City of Austin

RE: I-35 Capital Express (CapEx) Central Project, Austin, TX
City of Austin Comments on August 2021 Open House

Re: Technical Backup for Inclusion of Adopted Trail Crossings within I-35 Design Alternatives

RE: I-35 Capital Express South Project
Comments for Public Hearing

Northern Walnut Creek

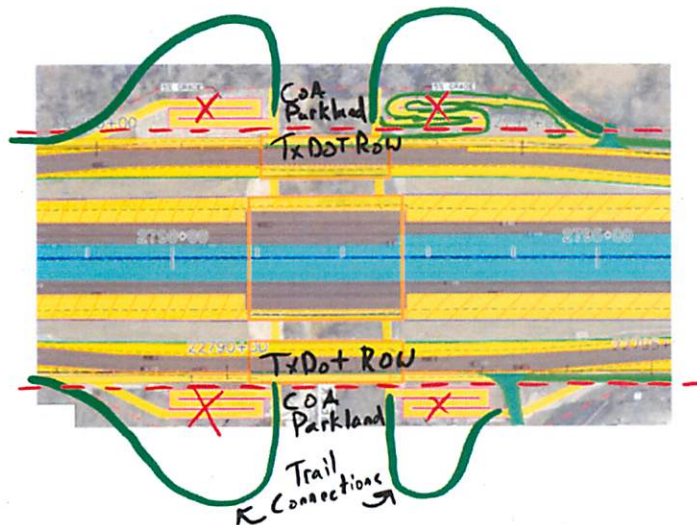
The drawing below shows a version of a previous schematic showing tight switchbacks to achieve connections between the I-35 SUPs and the Northern Walnut Creek crossings under I-35. If crossings are structured, they should be built with acceptable widths and radiuses. As noted above, ideally the connections use adjacent parkland and follow land contours for lower cost, reduced impact, superior design.

Middle Fiskville Crossing (between Rundberg and Baker)

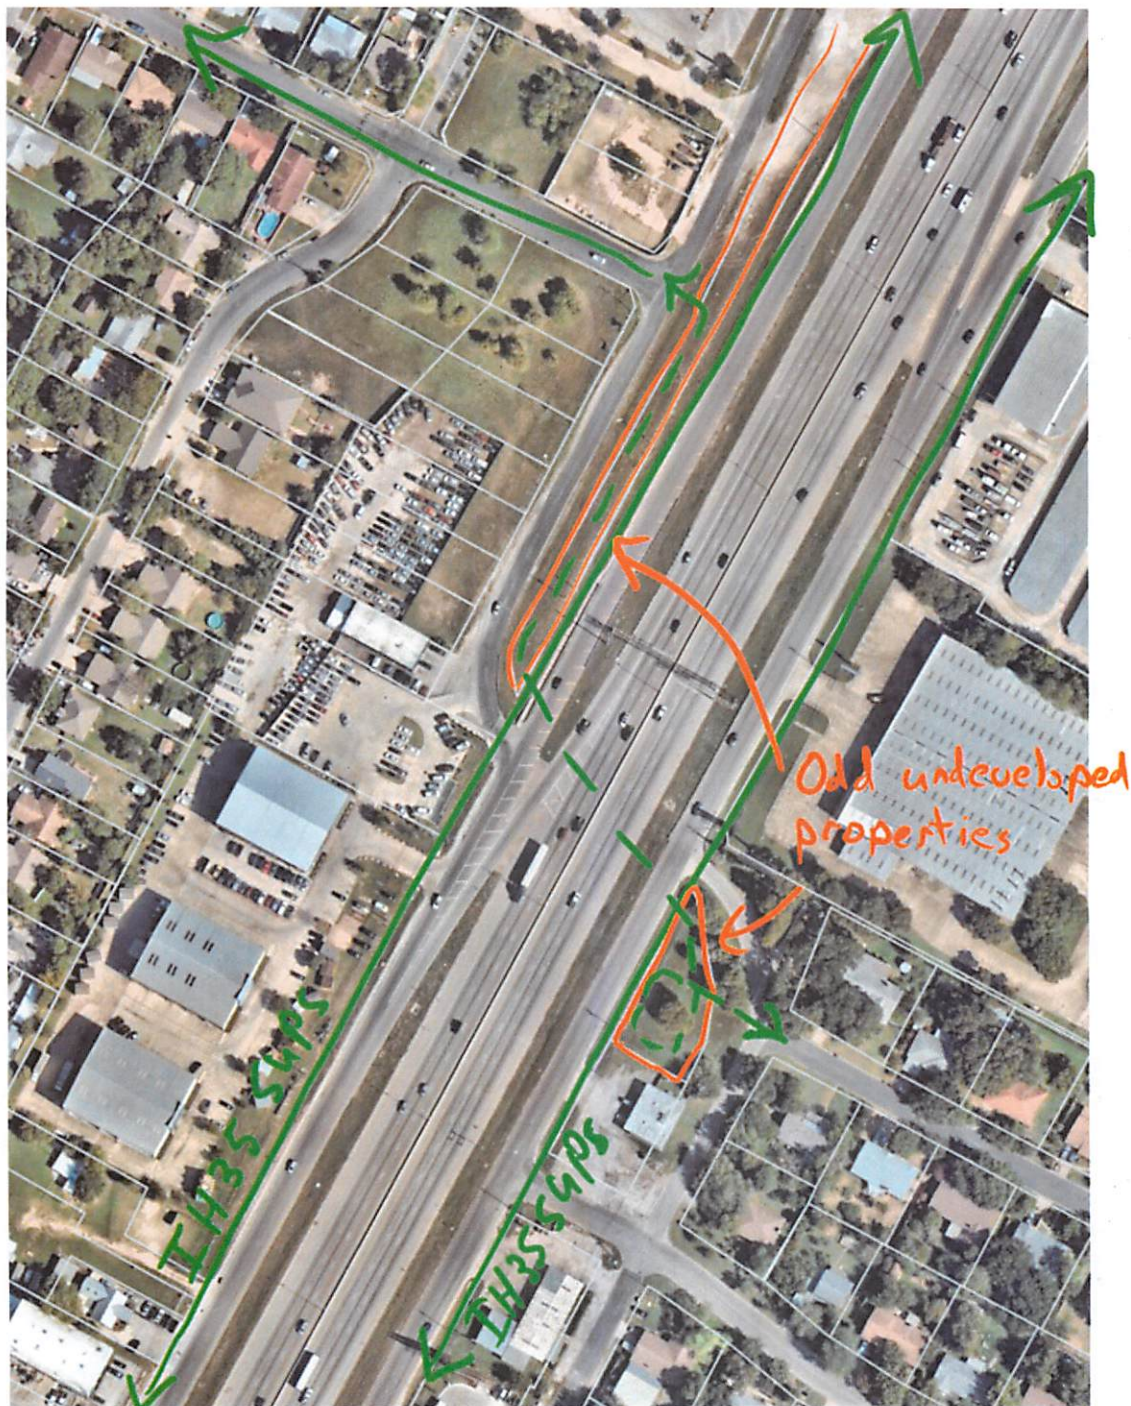
Rundberg to Braker has no creek crossings and is 1.5 miles apart. Middle Fiskville ROW aligns across I-35 providing the option for connectivity across I-35 to the local street network. Two odd shaped and undeveloped private parcels could serve to provide ramps for the overhead structure.

I-35 at 4th Street

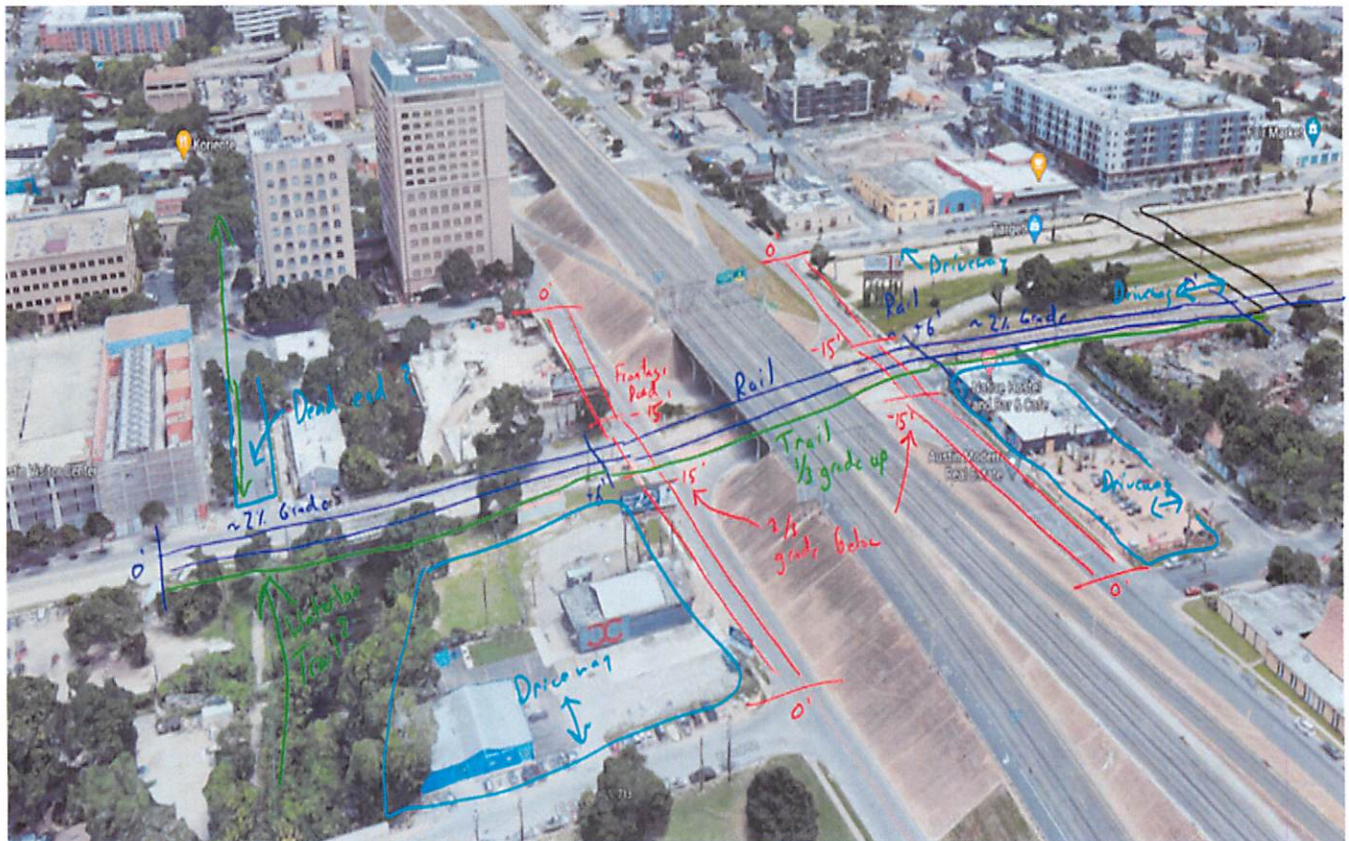
The proposal for managing the Capital Metro Rail Red Line / Green Line and LAB / Cross-town Bikeway crossing at 4th Street is an iteration of a suggestion by TXDOT staff at the I-35 Charrette. The idea would be to avoid interrupted operations of the frontage road by both the Rail and bikeway signals by grade separating the crossing. The rail and bikeway/pedestrian path would be at a +1/3 grade and frontage road at a -2/3 grade. The frontage road would tie back to existing grade at 3rd and 5th Streets

and the rail would tie into existing grade at San Marcos Street and just west of Sabine Street. The only property with driveways facing I-35 is the NW corner which is currently a construction staging area that could likely take its access off 5th Street exclusively. The properties on the west side north and south of 4th Street have billboards that would need to maintain access which could potentially be achieved through the SUP. This concept would achieve much superior reliability for downtown ingress / egress for the capacity constrained frontage road / CD roadway serving the heart of downtown.

I-35 at Lady Bird Lake

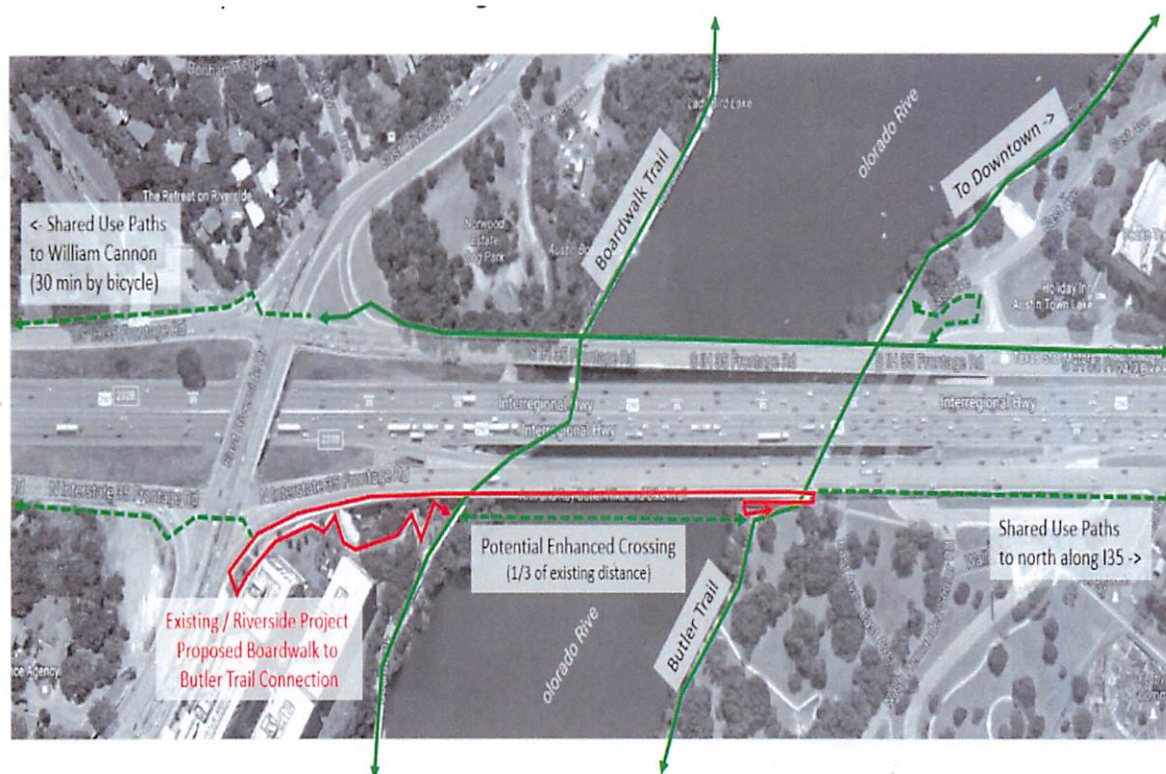
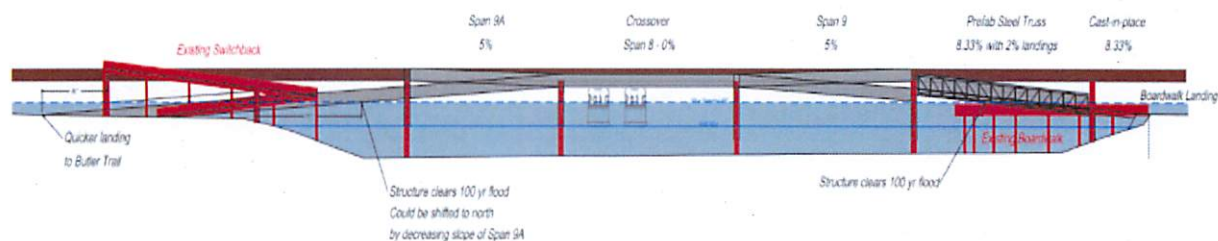
I-35 at Lady Bird Lake has critical connectivity between the I-35 SUPs and the Boardwalk and Butler Trail that is a critical connectivity component of a signature bridge. The main connection is proposed on the east side of the bridge due to the boardwalk landing which is a good takeoff point for the SUP structure over the lake. The proposed elevation and column spacing has been vetted and modeled with Watershed Protection Department (100-year storm modeled), is compatible with rowing lanes (columns aligned with IH35 columns) and allows double decker river boats continued access of Lady Bird Lake to the east. The connection addresses the existing switchbacks for the SUP connection that do not meet SUP design guidance as well as reducing the connection to 1/3 of its current length.

*I35 SUP Bridge
 5% slope to Boardwalk and Butler (8.33 for north span)
 Lowered Flat Center Span*

Teri Road and Colonial Park Drive

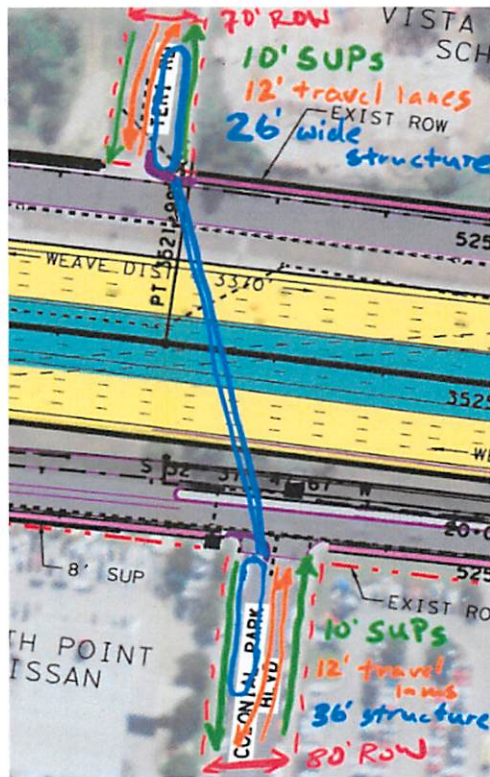
Teri Road and Colonial Park Drive are both wide streets and ROWs that align across I-35. Overhead or tunnel structures could sit in the ROW or even current street space. Colonial Park Drive is a grade below Teri Road.

Cantilevered frontage roads over CD system

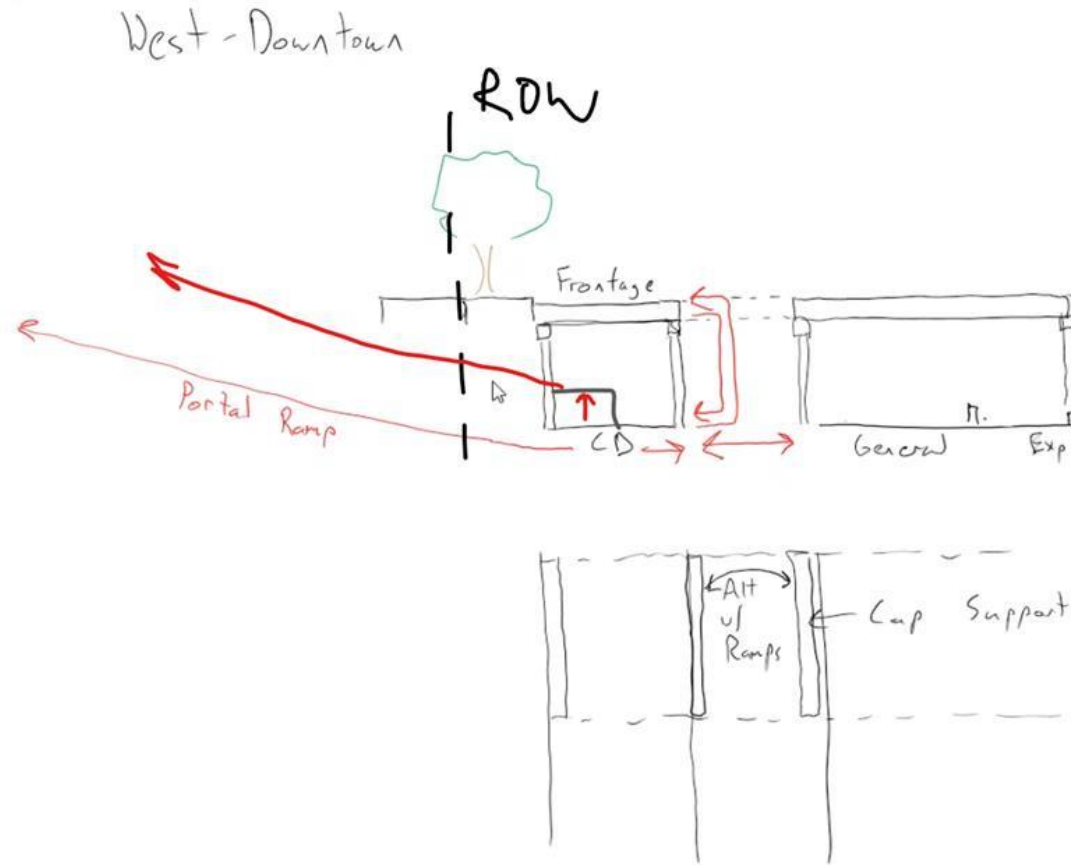
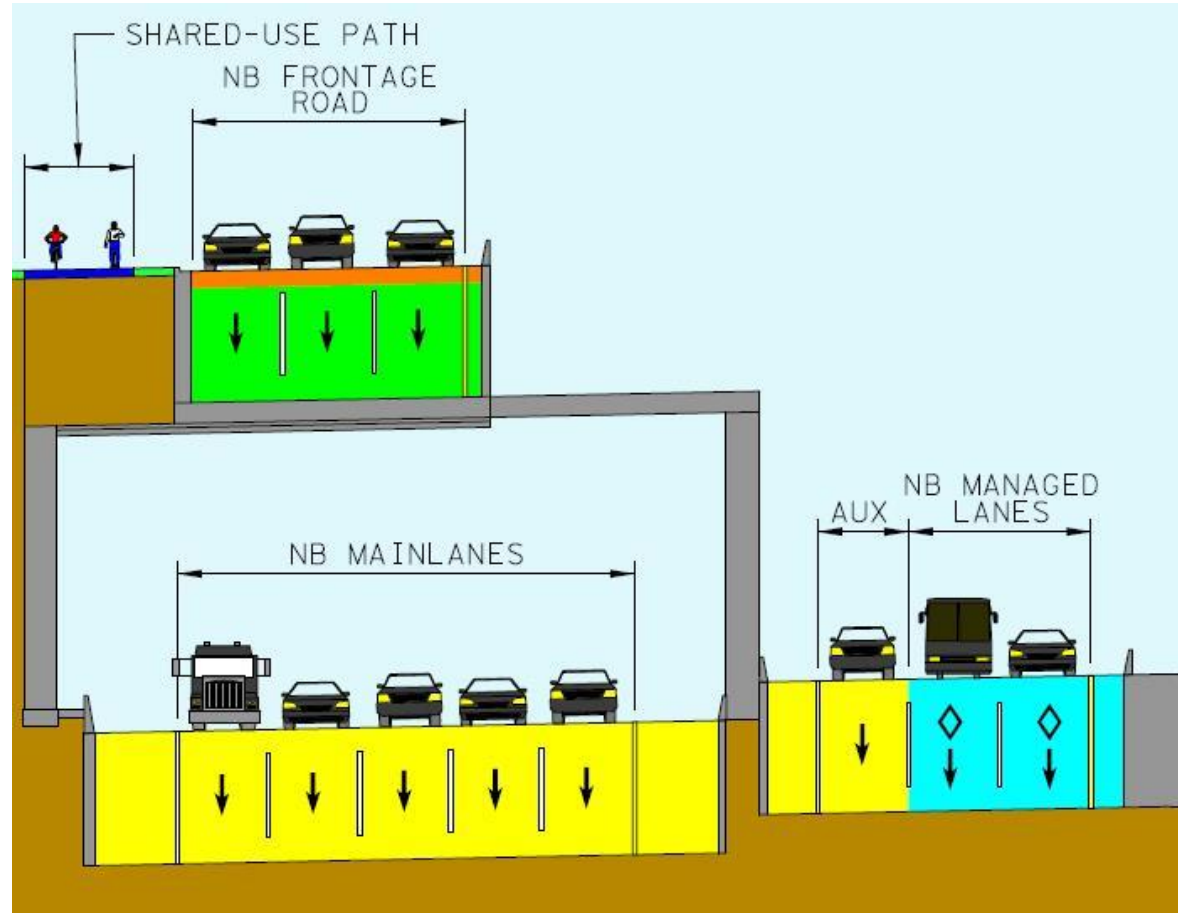
Cantilevered frontage roads over CD system

Cantilever design: extended to other segments?

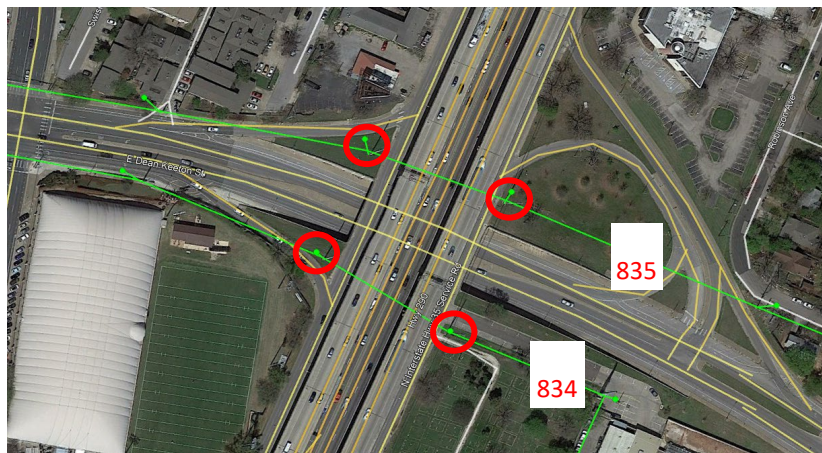
- It is unclear from reviewing Alternatives 2 and 3 whether maintaining the access to the nearest driveway access to the substation from the frontage road is being contemplated. The input at the Open House indicated it could be a drawing error that only one of the driveways was indicated as remaining.

There are other access points to this substation from 38th Street, but the I-35 Highway frontage road is most desirable. Austin Energy appreciates TxDOT maintaining access to this substation in its current plans and Austin Energy asks that TxDOT continue to accommodate Austin Energy's access requirements to this substation as it finalizes its plans for the I-35 Capital Express Project.
